> RE Site Plan Application Stephen Compagni / Economy Paving Co., Inc. 1819 Route 13

Drainage Evaluation 1799/1819 NYS Route 13 Cortlandville, NY

1998 Survey

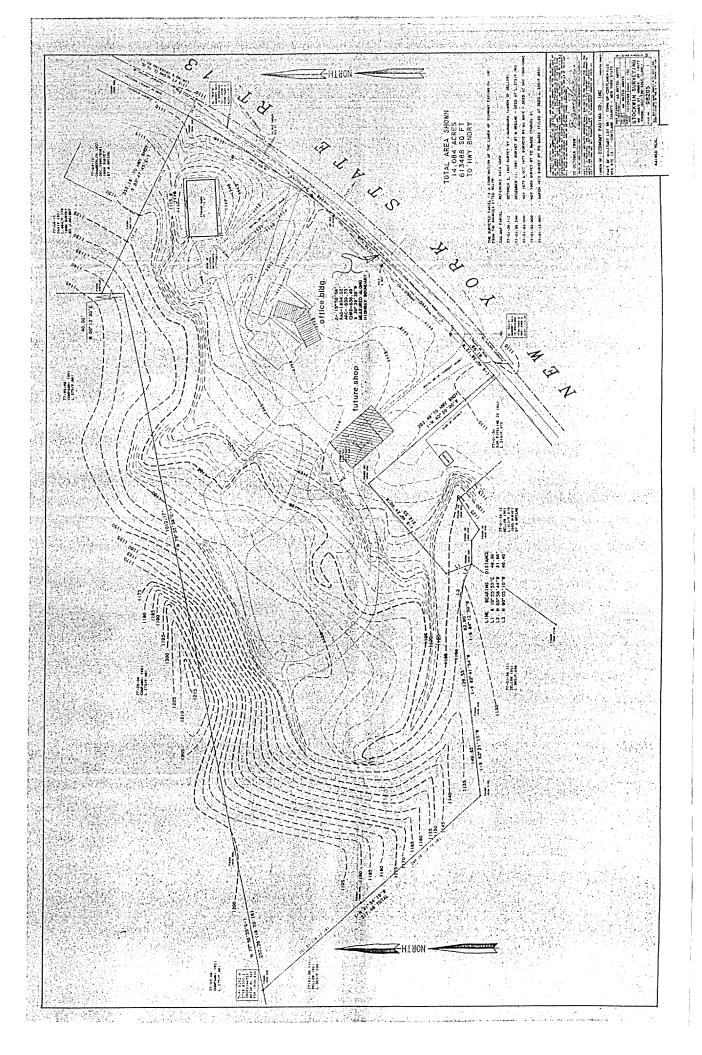
During our evaluation of the materials noted above we reviewed surveys for the two properties. One survey of both properties dated 10/28/98 (Attachment A) shows topography and site features for both sites at a time prior to any development on the 1819 parcel. Drainage patterns show existing flows from the upland areas to the north flowing south toward NYS Route 13, generally. Areas within both sites (1799 and 1819 NYS Route 13) both contain high points and low points which direct runoff to the southwest and northeast. One main path appears to flow between the two properties almost exactly north to south toward NYS Route 13 following their mutual property boundary. It appears water flowed around the buildings and paved areas located on 1799 eastward and southward along the mutual boundary toward NYS Route 13 under conditions prior to development in the year 1999. In addition, only a small sliver of land flowed along this mutual property path. Surveyed topography contained in the 1999 Stockwin Survey document shows a high point ridge located on 1799 from it's northwest corner thru the garage noted on the 1799 property and to approximately a point on the mutual property boundary about 80-100 feet north of NYS Route 13. Additionally, another high ridge appears to be located along a path between the area designated as "future shop" on that survey and NYS Route 13. This would allow only a small watershed to be contributory to an area between 1799 and 1819 along the mutual property line for any runoff to flow.

1999 Wendt Design

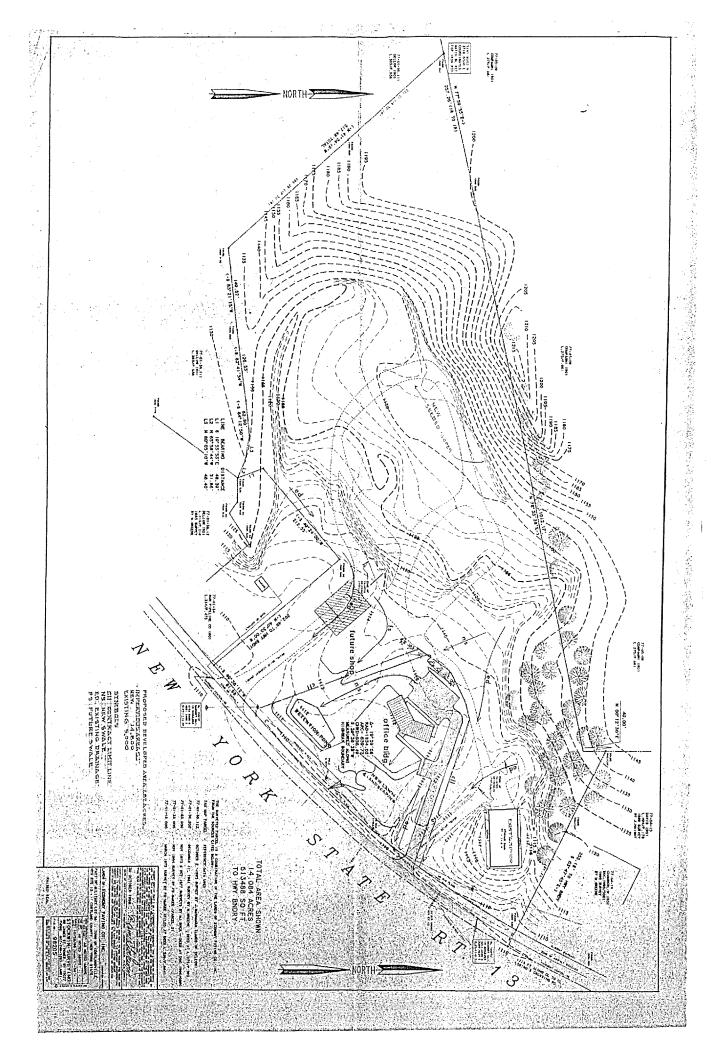
These patterns appear to have been altered as part of the 1999 Wendt Design Attachment B). The 1999 Wendt design includes a "future shop" and shows drainage labeled as "ed" (assumed to be "existing drainage") and "fs" (assumed to be "future swale"). This "fs" depicts what is assumed to be channelized drainage around the "future shop" instead of thru it as the "ed" and existing contours would suggest happens under pre development conditions. This "fs" or future swale" appears to discharge to an area labeled "retention pond" which makes reference to a common stormwater management practice in 1999. The retention pond noted also appears to accept runoff from the office building and impervious surfaces around it in an effort to mitigate the increases in runoff generated by the development. This rerouting of runoff from upland areas to the north around the "future shop" and to the retention pond would significantly reduce the amount of runoff flowing along the 1799/1819 mutual property boundary. As part of the 1999 application and project approval, an Engineer's Report on Stormwater Management Plan, prepared by LaCross Development was submitted. This Engineer's Report further confirms that water from upland areas to the north and west was to be routed behind (to the north of) the future shop and to the "detention pond" (as it's referred to in the Engineer's Report). The site plan sketch included with this Engineer's report is presented as Attachment C. It should be noted that the "future shop" was not constructed as part of this application. After comment by the Cortland County Soil Water Conservation District in August of 1999, Wendt resubmitted a map (Attachment D) showing drainage patterns and how they would be constructed as part of the development in September of 1999. As we understand it, some time after the resubmittal the office was constructed in accordance with these documents.

2001 Resource Associates "Mechanic Facility" Site Grading Plan

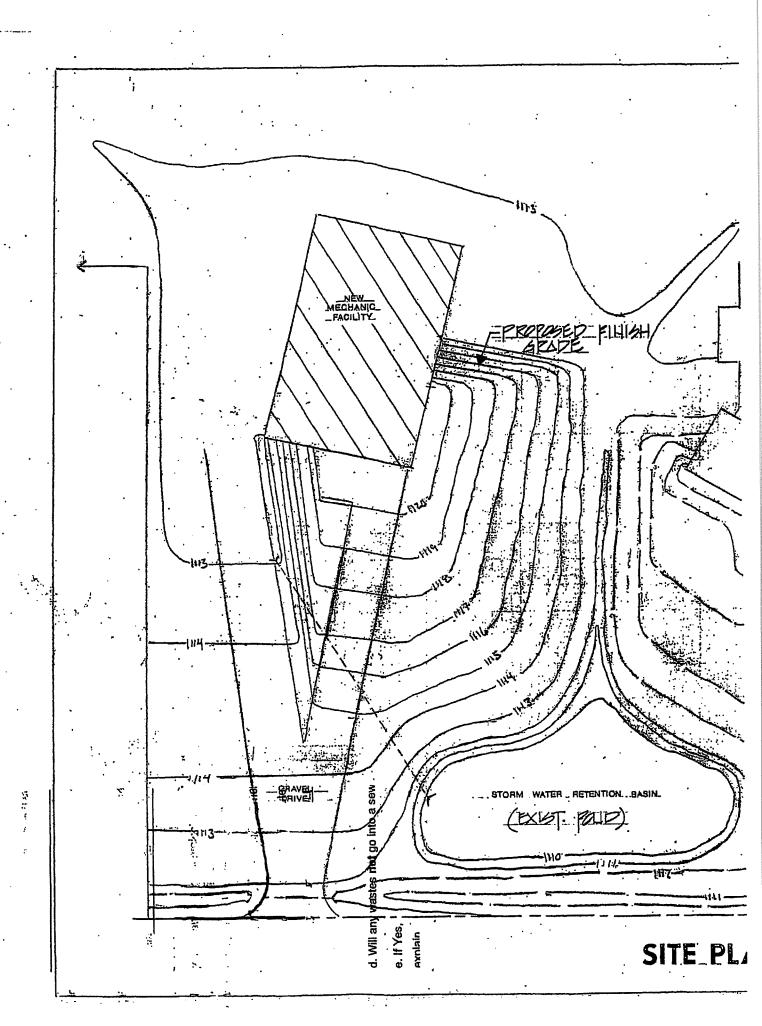
The drainage patterns appeared to have then been altered again, in contradiction with the 1999 plans when Economy Paving attempted to build the Mechanic Facility (previously referred to as the "future shop"). As part of Economy Paving's application an "Application for Aquifer Permit and Conditional Permit" was prepared by Resource Associates in May of 2001. This application included a "Site Plan" showing a new culvert to the existing "Stormwater Retention Basin" on the basin's western side to the south of the new Mechanic Facility. This culvert is shown to start east

of the Mechanic Facility Driveway and flow to daylight within the basin. The drawing does not denote whether this pipe is existing or proposed. However, we would conclude that it would be proposed, since the 1999 plan shows the majority of the drainage from upland areas to flow around the rear (north) of the Mechanic Facility and such a culvert would be unnecessary if the 1999 plan was adhered to. Additionally, a Site Grading Plan (Attachment E) was included within the Engineer's report. This plan further defines the proposed drainage concept and shows the new culvert to the pond accepting runoff from the driveway and areas west of it between the driveway and the 1799 NYS Route 13 property. Grading proposed on this plan severely alters the drainage concept from the 1999 plan and appears to no longer send runoff around the rear (north) of the Mechanic Facility. A low point is created by this plan located between the new Mechanic Facility and the 1799 property to the west by a local high point within the new driveway. No provisions to divert runoff away from 1799 NYS Route 13 are visible, however, it appears the intent is to send runoff thru this new culvert, under the new driveway to the Mechanic Facility and into the basin. No pipe sizing calculations or other engineering design such as spot elevations or flow directions, flood routing or integration into existing topography appear to be shown within this document.

2014 Ianuzi & Romans Survey of 1799 NYS Route 13

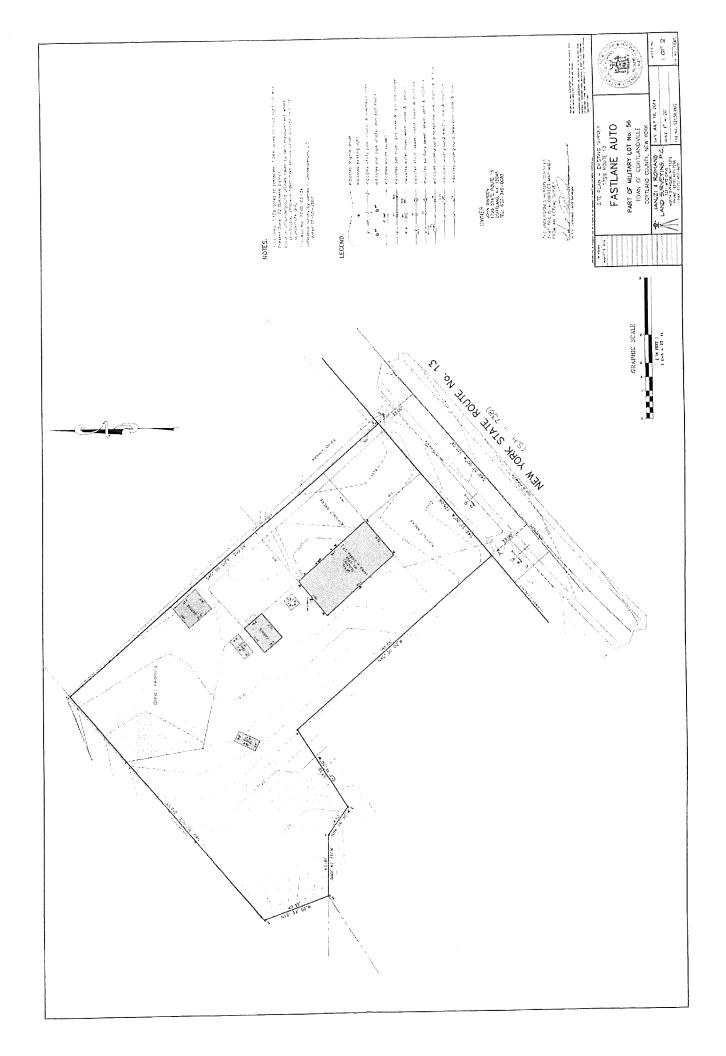
As evident from the existing topography and design intent from the 1999 approved Economy Paving plans, the property at 1799 NYS Route 13 is not a defined or designated drainageway for runoff from the Economy Paving site or it's upland areas to the north and west. A topographical Survey was performed by Ianuzi & Romans Land Surveying PC of the 1799 property in July of 2014 (Attachment F). The survey shows a low point of elevation 1112 located on the mutual property line between properties 1799 and 1819 NYS Route 13 approximately 80-100 feet north of Route 13. This low point appears to correspond with the low point proposed to be created as part of Economy Paving's 2001 Mechanic Facility site plan (Attachment E). While no inverts of the proposed culverts were identified on the 2001 Site Plan by Resource Associates, one could estimate the inverts (based on appropriate pipe cover required) to be somewhere around 1111-1112 for the inlet and 1110 for the outlet to the pond. With surrounding grades of 1113-1114 on both properties and the top of berm elevation within the basin of 2014, it is unclear to us how the proposed plan from 2001 would prevent uncontrolled runoff from the Economy Paving site at 1819 NYS Route 13 from flowing onto the 1799 property. Furthermore, it appears the 1799 property may be subject to backflow from the basin during storm events that fill it.
